Town of Breckenridge
Planning Commission Agenda
Tuesday, July 5, 2011
Breckenridge Council Chambers
150 Ski Hill Road

PLANNING COMMISSION MEETING

- Project Manager:** Michael Mosher, Planner III
- Date:** June 22, 2011 (For meeting of July 5, 2011)
- Subject:** The Elk, Mixed Use Building and Variance Request (Class A, Final Hearing; PC#2011001) - *(The last meeting was a second preliminary hearing.)*

2
A-4
West Elevation
Scale: 1/4" = 1'-0"

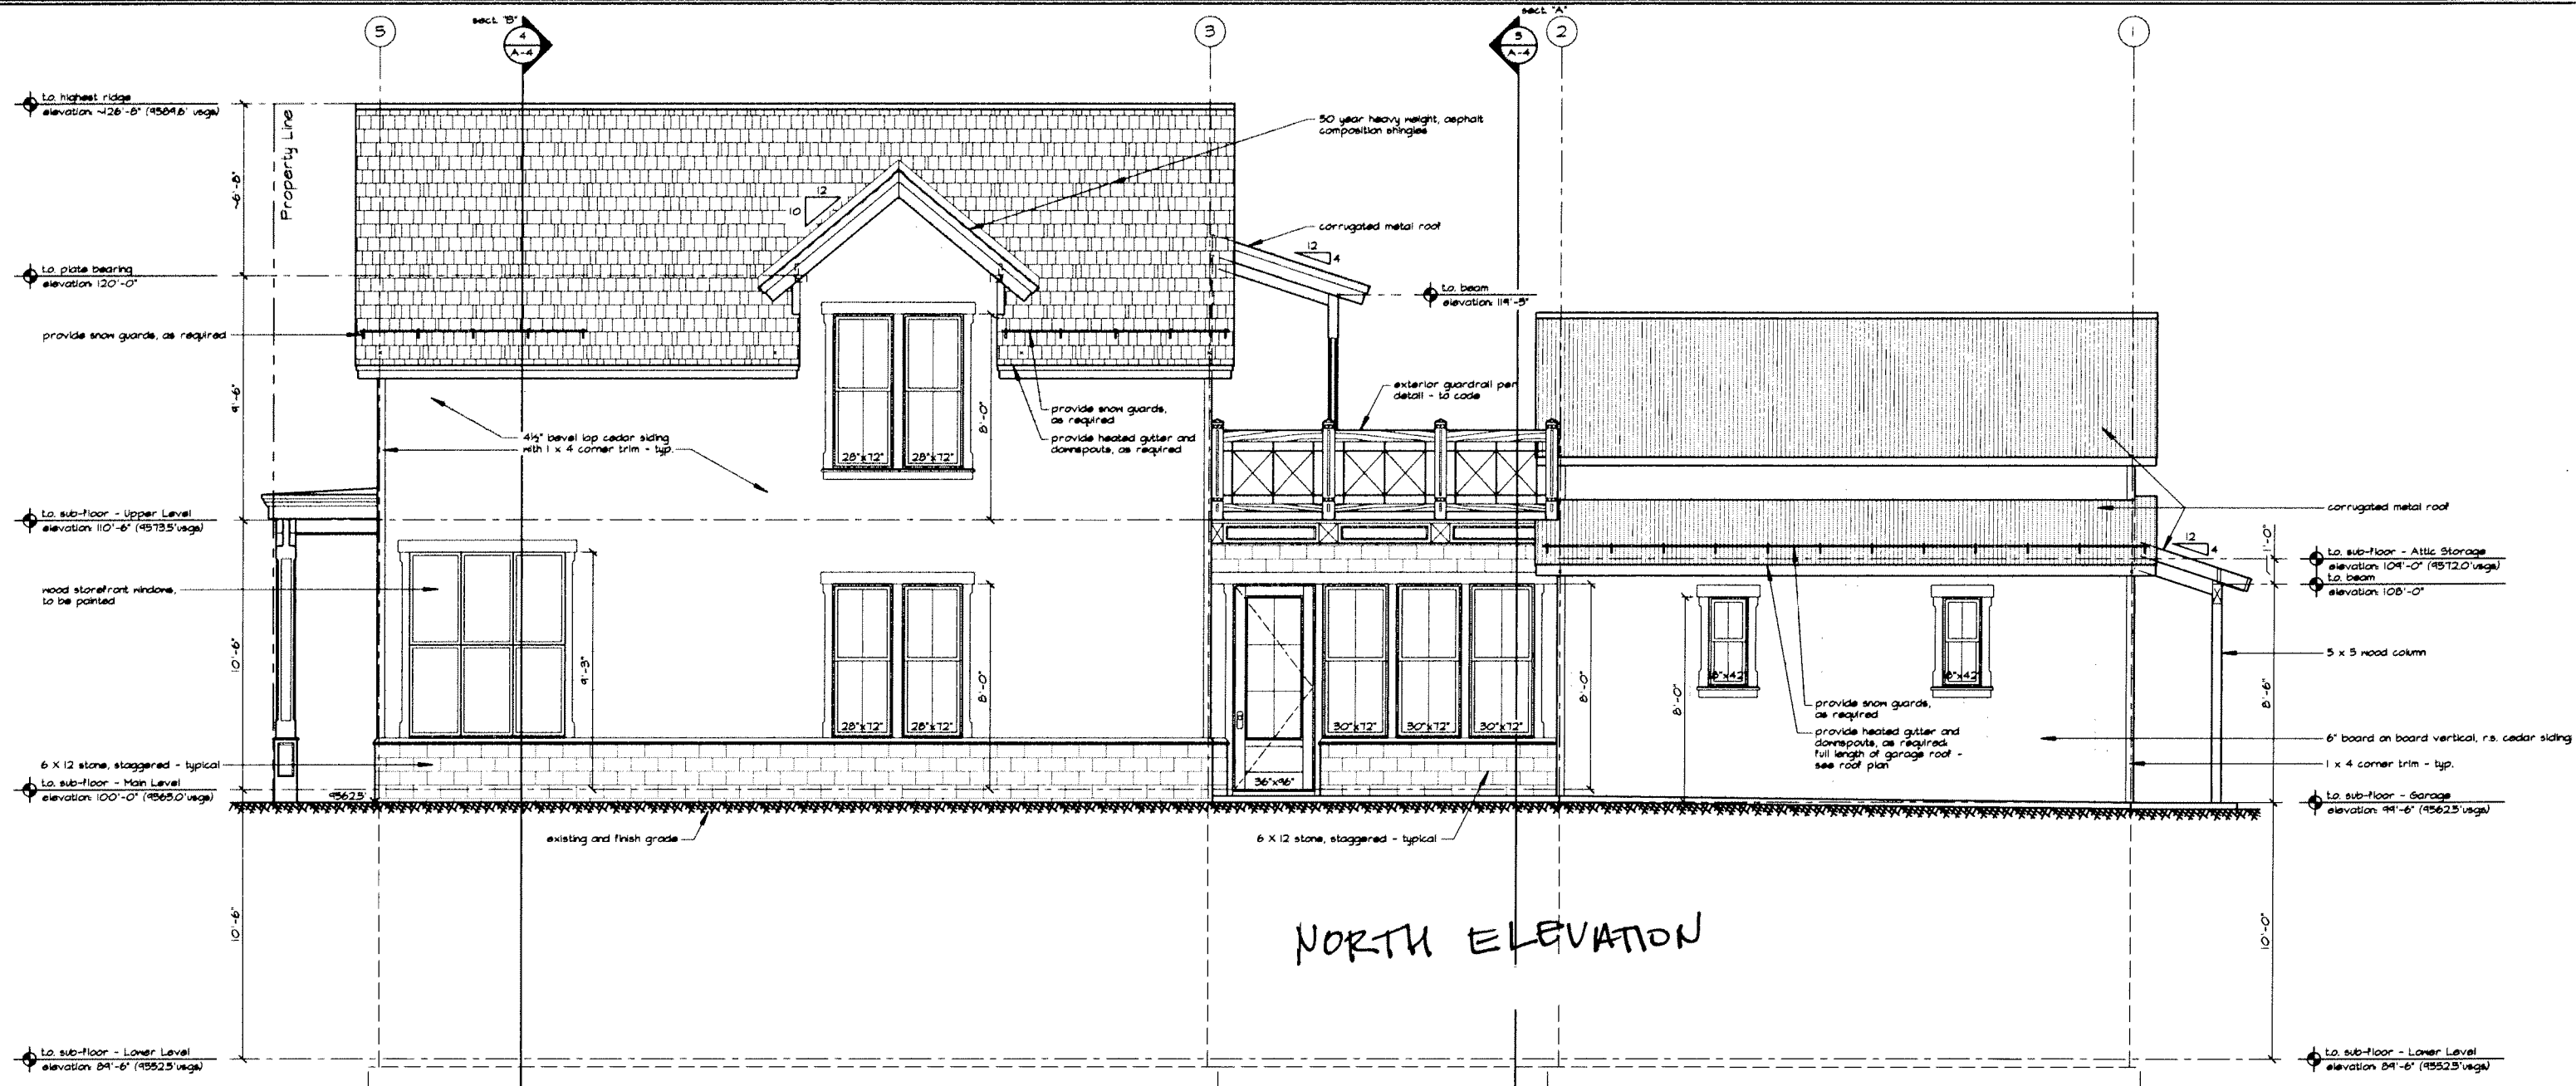
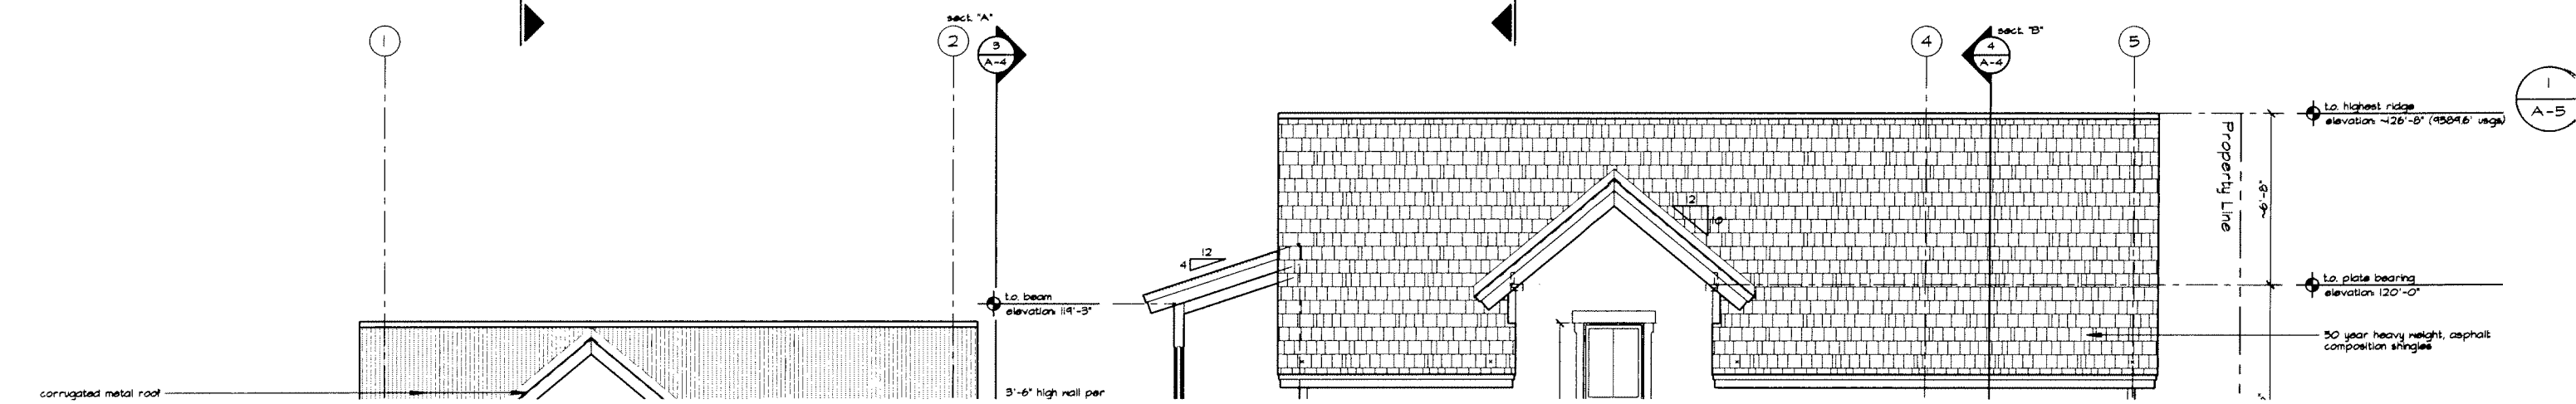
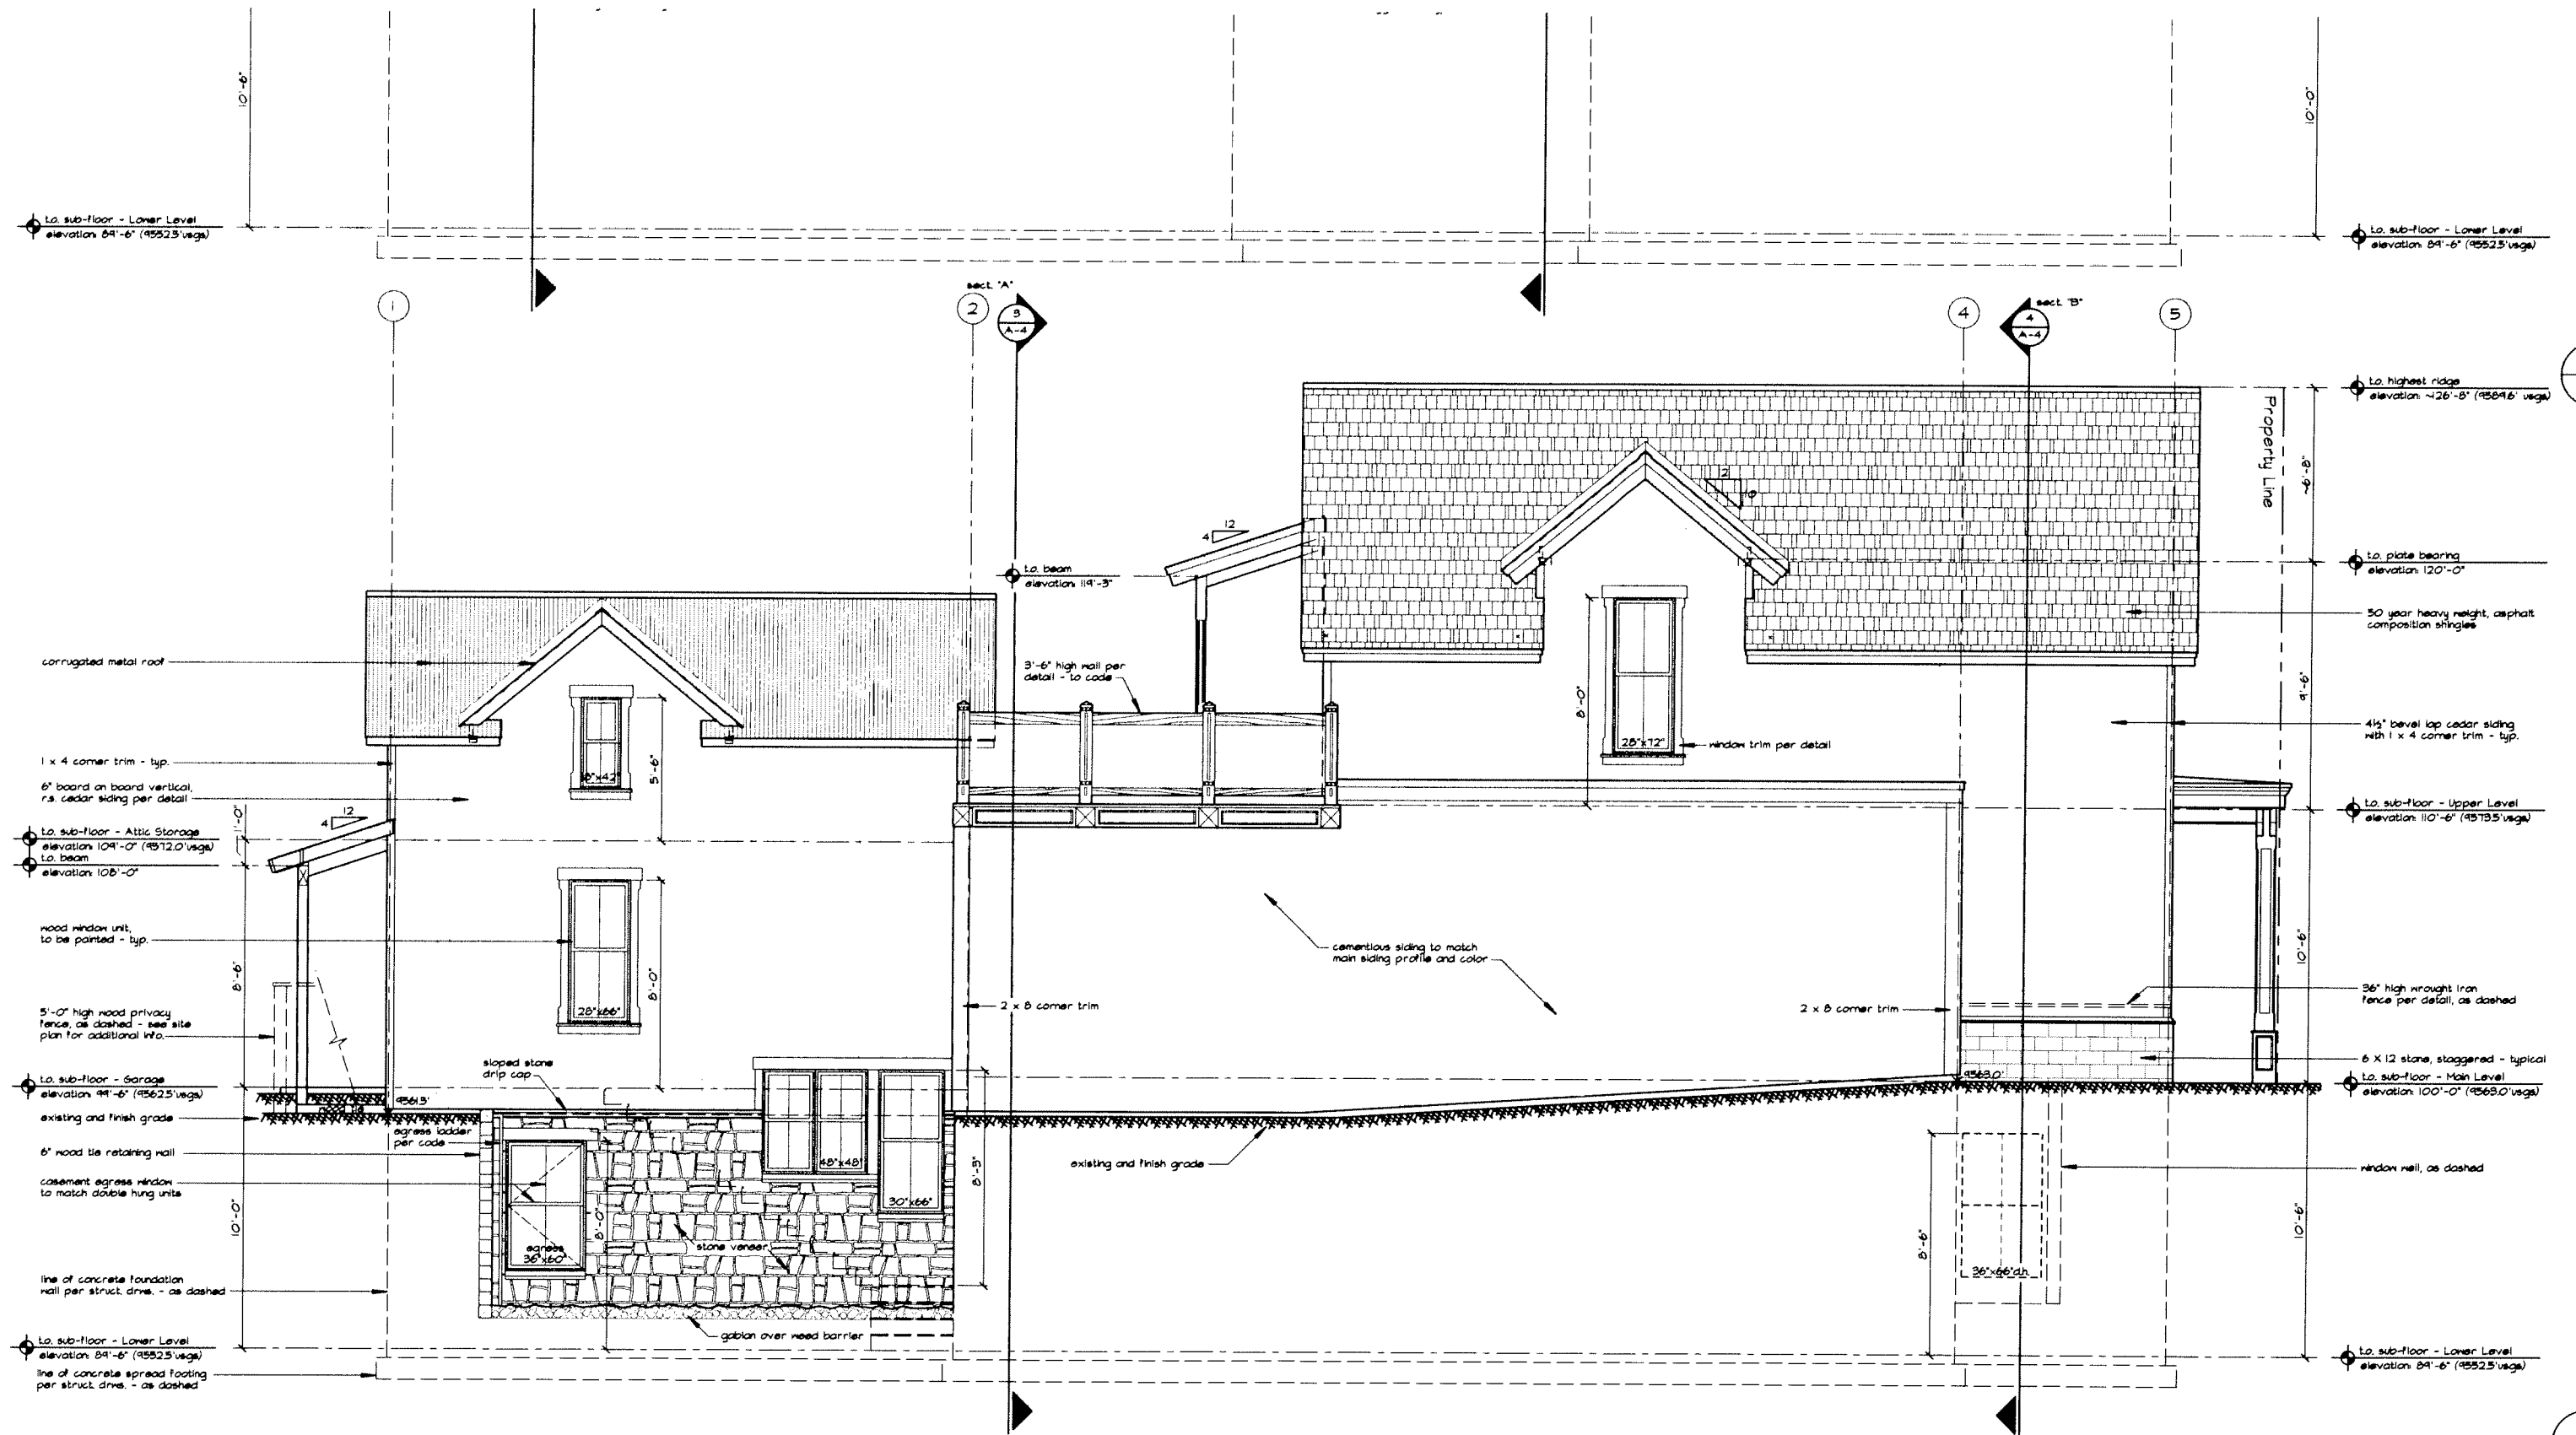
The proposed drawings show a link that meets the intent of this policy on the north elevation. Though not meeting the exact criteria, the wall planes are set back two-feet, the height of the connector is clearly lower, and the separation of the larger masses is effectively accomplished by the length of the connector.

For the general public, the change in the design of the connector would not be apparent. From three sides (east, north and west) the larger modules would appear separated like other buildings with connectors in the Historic District. From those vantage points, the connector effectively separates the larger modules and is subordinate in mass and scale.
